Office Action Summary	Application No. 10/565,844	Applicant(s) MORIKAWA ET AL.	
	Examiner BENJAMIN KURTZ	Art Unit 1797

DETAILED ACTION

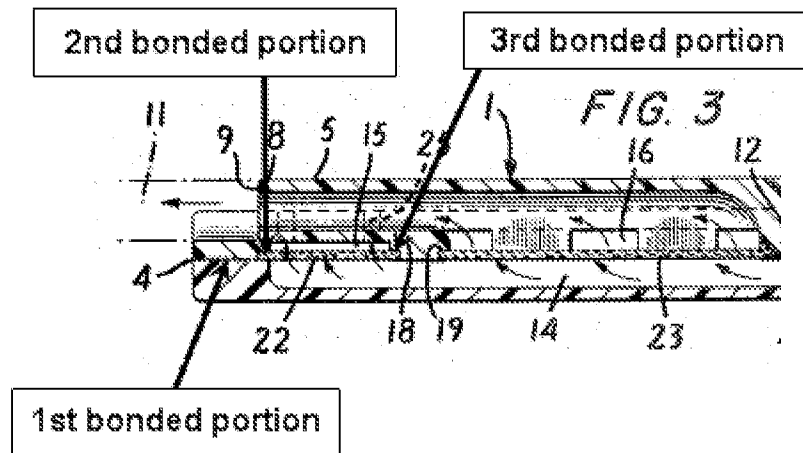
Claim 5, Rosenberg teaches a case with a partitioning member comprising: a case (2), a cover (3) and a partitioning member (22) which is held between the case and the cover partitioning the interior of the case and the cover, characterized in that a second bonded portion (see below) in which the case and the partition member are bonded to each other is provided on the inside of a first bonded portion (see below) in which the case and the cover are bonded together, a third bonded portion (see below) in which the case and the partitioning member are welded to each other is provided on the inside of the second welding portion, and a hole (25) open to the atmosphere is provided in the case between the second bonded portion and the third bonded portion (fig. 3). Rosenberg teaches the partitioning member bonded to the case and the case and cover bonded to one another but does not teach the process of welding. “[E]ven though product-by-process claims are limited by and defined by the process, determination of patentability is based on the product itself. The patentability of a product does not depend on its method of production. If the product in the product-by-process claim is the same as or obvious from a product of the prior art, the claim is unpatentable even though the prior product was made by a different process.” In re Thorpe, 227 USDQ 964 (1985). The bonding process of Rosenberg is taken to be a structural alternative to the welding process disclosed herein.

Claim 6, Rosenberg further teaches the bonding allowance in the first bonded portion of the case is higher than a bonding allowance in the second bonded portion of the case (fig. 3).

Claim 8, Rosenberg further teaches the casing is divided into a dust side on the upstream side of the filter and a clean side on the downstream side by the filter element, and the second and third bonding portions are provided on the dust side of the filter element (fig. 3). The dust side being (15) and clean side (14).
